**5/15/2024 | 6:00 PM**

**Municipal Services Center, Council Chamber  
3600 Tremont Road**

The applicant will be present to share revised plans for a detached garage with a second floor office space. At the April 17th meeting, the Board shared concerns about the height of the proposed garage being located so close to the side property line. The Board also recommended reducing the size of the front window, adding landscaping to help screen the garage from neighboring properties, and pushing the garage farther back from the street. There was also concern about the garage being taller than the nearest roofline on the home and not having a complimentary scale/massing as the home.

# Proposed Garage Elevations

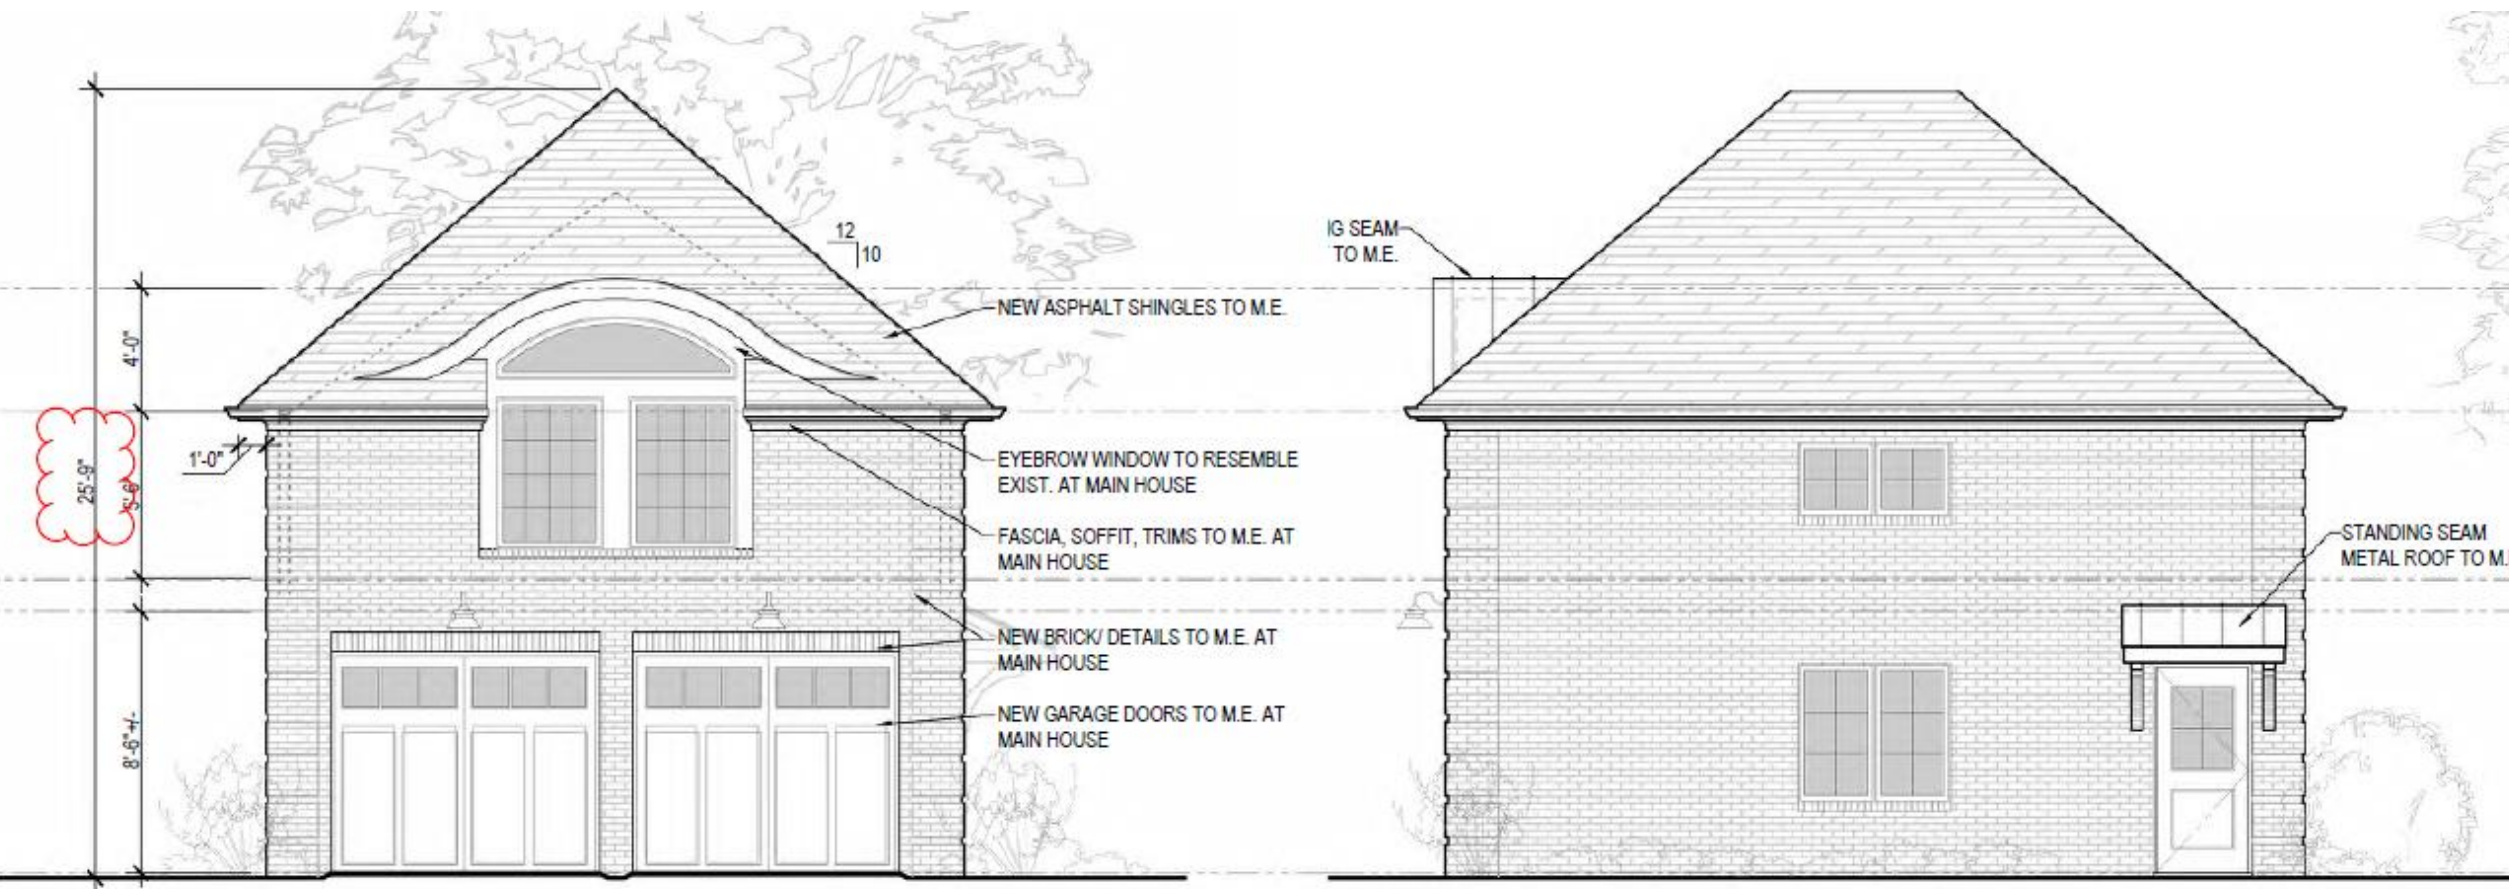
Staff has reviewed the application and plans, visited the site, and discussed with the applicant. In this case, Staff has concerns with a nearly 26-foot tall detached garage as close as 5'-3" from the side property line. Staff has found this would be out of character for the neighborhood, especially since the home is in the R-1a district, where lot sizes are larger and setbacks are deeper than many other neighborhoods in the City. Staff understands the applicant's desire for an additional garage and living space and appreciates the architectural detailing of the proposed garage. However, this would be the tallest detached garage approved by the Board and could result in impacts on neighboring properties; it could also become a precedent-setting request for height of detached garages. For these reasons, Staff would recommend a height reduction of at least 3'-9", which would be more in-line with other detached garages recently approved by the Board, and the addition of landscaping and/or fencing along the side property line. The Board may consider Finding #4 with this request.
